### CHAPTER 3 DEIS COMMENT SUMMARIES AND RESPONSES

This chapter summarizes and responds to all substantive comments that OEA received on the DEIS. In total, OEA received 72 written/electronic comments on the DEIS. These written/electronic comments have been included in Appendix A of this FEIS in the order in which they were received. The majority of these comments were received on or before the DEIS comment deadline of September 28, 2010. However, OEA also accepted a number of comments that were received after this deadline. Comment letters on the DEIS from the cooperating agencies, USACE and FHWA, have been included in a separate appendix (i.e., Appendix B). Additionally, OEA held a public meeting for the DEIS on September 14, 2010, at which 18 individuals provided oral comments. A complete transcript of the public meeting, including all 18 oral comments, has been included in Appendix D of this FEIS. Several commenters at the public meeting submitted prepared statements, which have subsequently been included as part of the written comments in Appendix A.

**FIGURE 3-1**  
**SNOW SHOE MULTI-USE**  
**RAIL TRAIL**

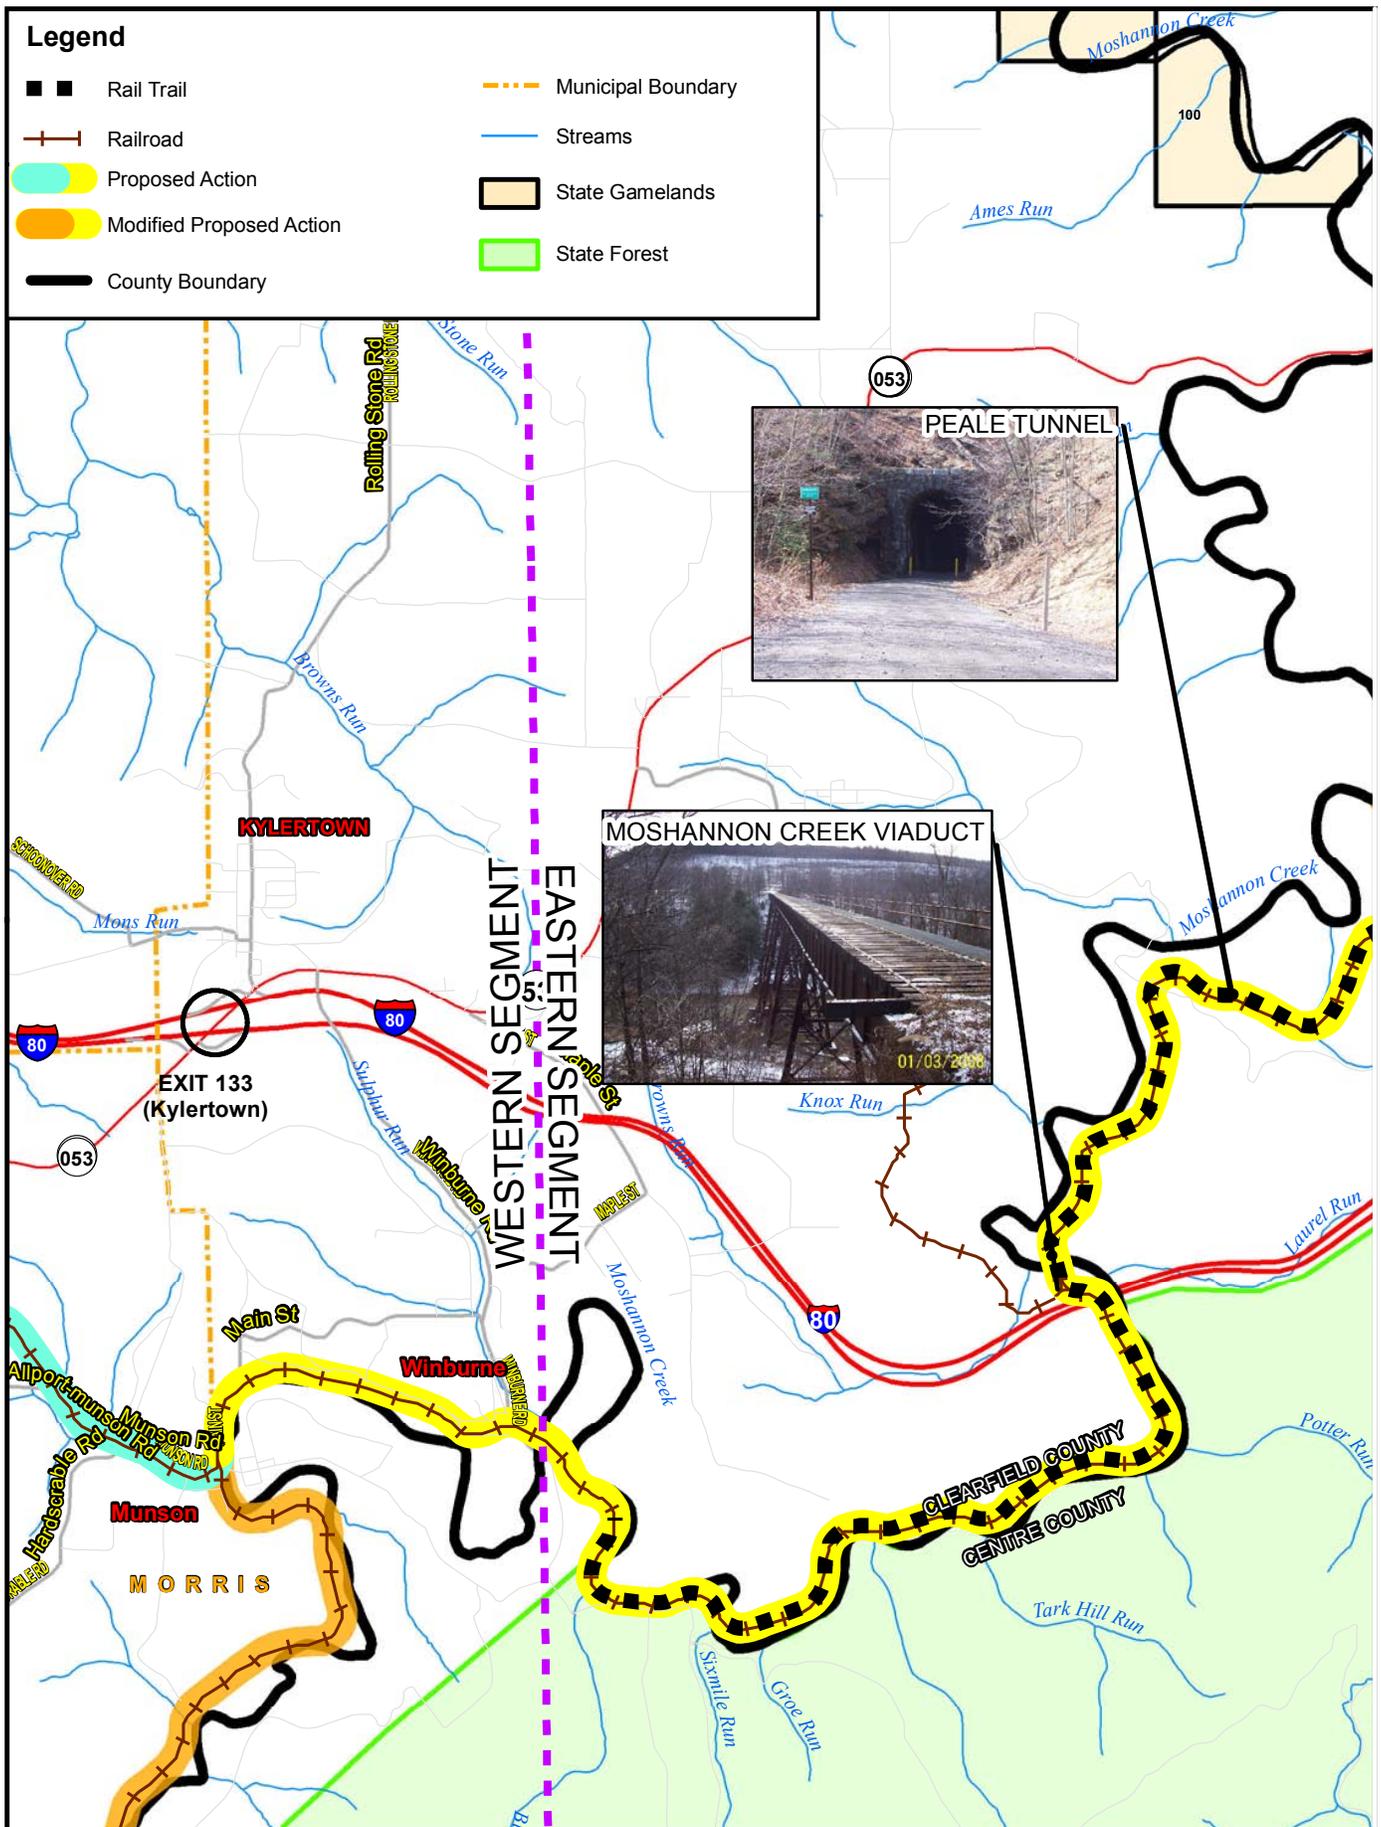
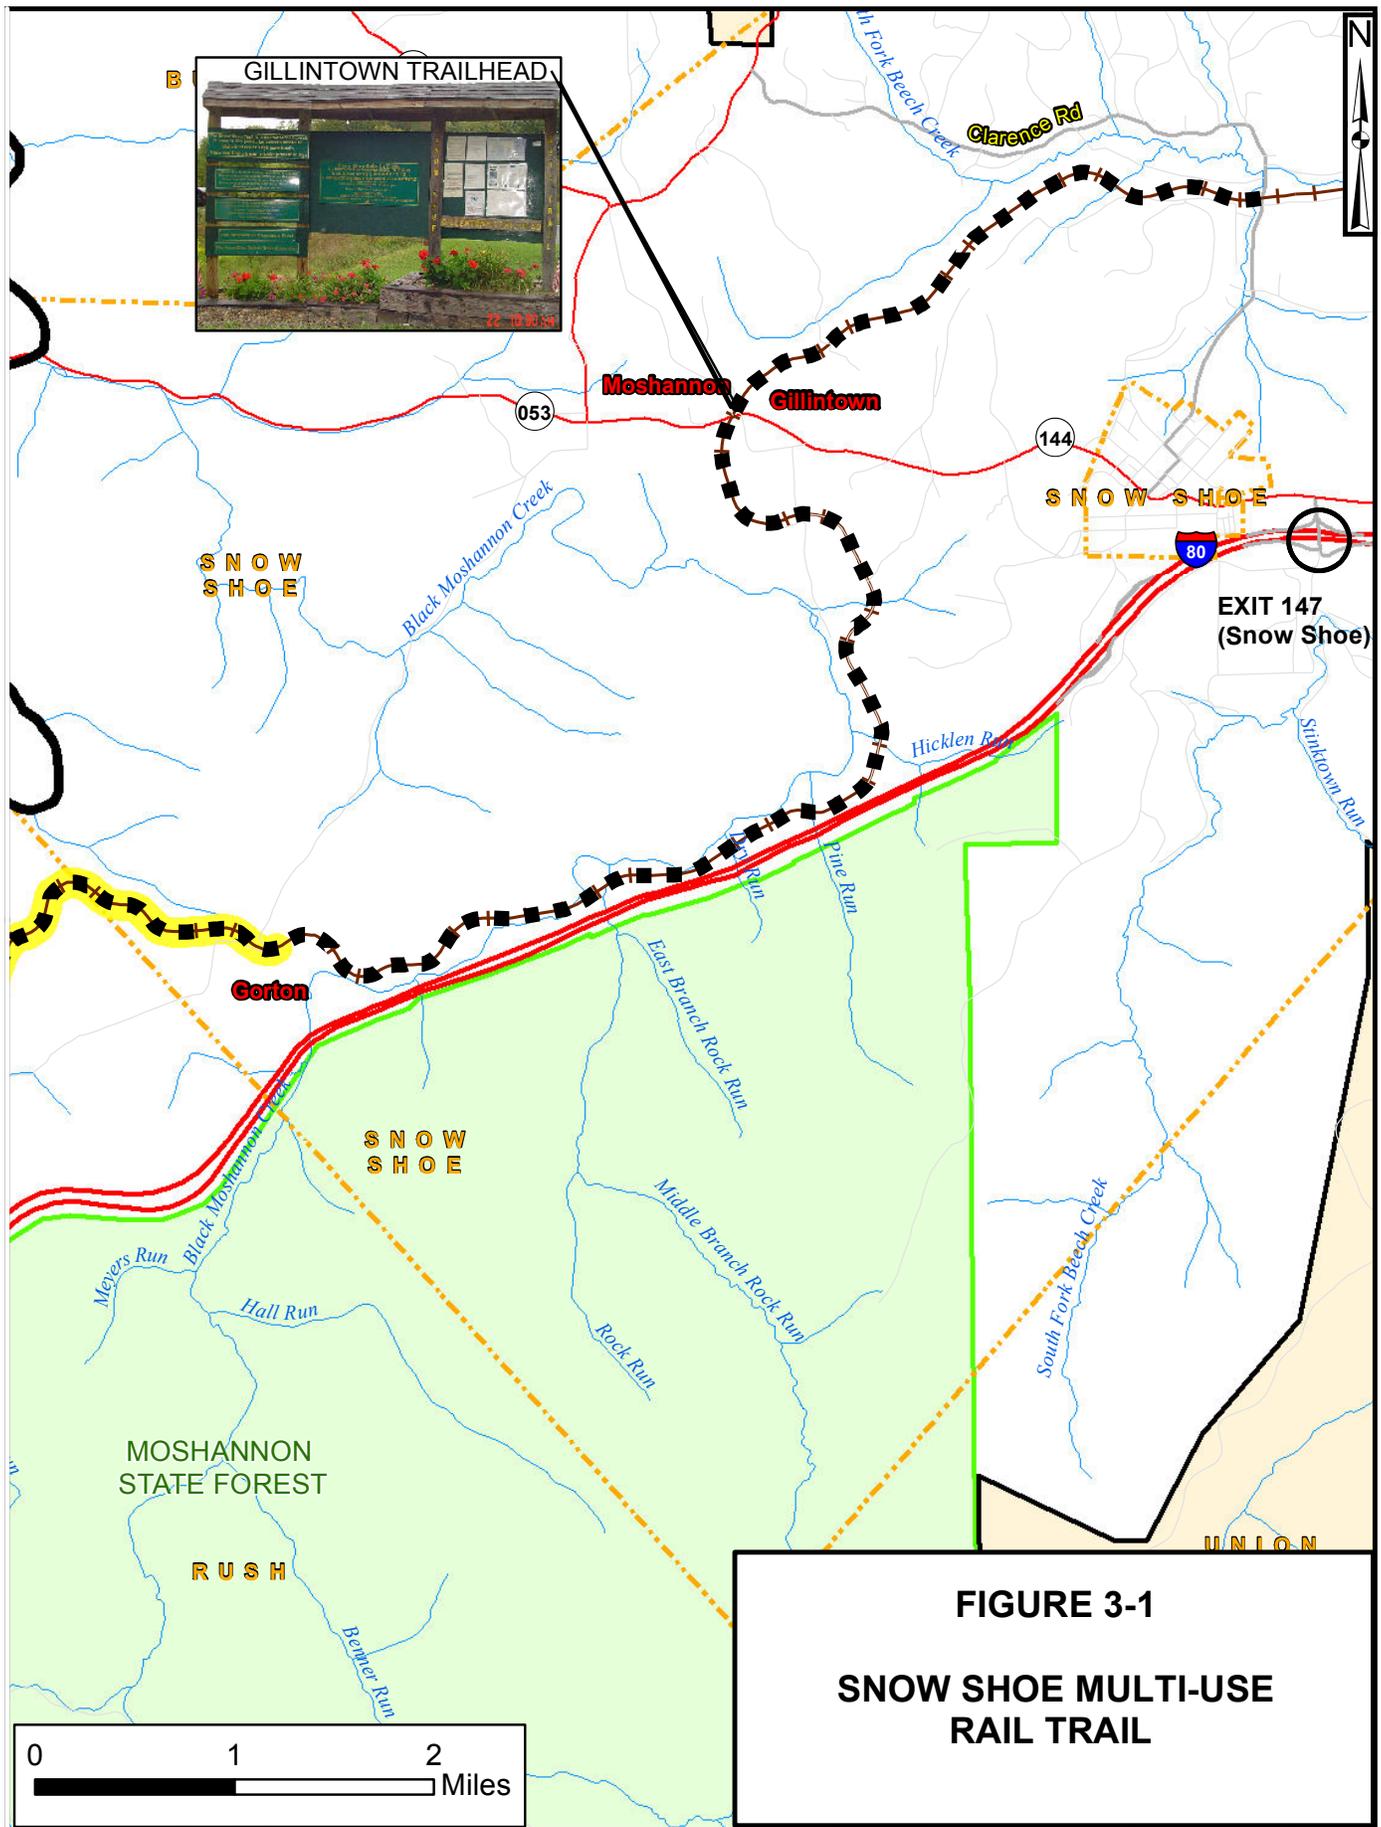
**DEIS CA-1:** Several commenters stated that they were aware of USACE's decision to discontinue its participation as a cooperating agency for this project, and that the DEIS should be revised to reflect this change. Citing this change in cooperating agency status, one commenter indicated that he was "extremely disappointed with the DEIS, most of which is based on incomplete or outdated information."

In its September 1, 2010 comment letter on the DEIS (see Appendix B), USACE stated that “based on the information received by this office, and in looking at the work that falls within our scope of review, it appears that the proposal within our scope of analysis may not have a significant effect on the human environment... (thus) it appears that an EIS will not be required as part of our permit review process.”

Because of this determination, USACE stated that it does not need to serve as a cooperating agency for this project and will conduct its own independent environmental review during future review of permit applications. This change in cooperating agency status is discussed in Section 1.5 of this FEIS. In response to the commenter who was disappointed that this information was not presented in the DEIS, OEA notes that USACE’s decision to terminate its participation as a cooperating agency was first presented in its DEIS comment letter and was based on the detailed environmental analysis presented in the DEIS. Therefore, OEA only learned of USACE’s decision after the DEIS was issued.
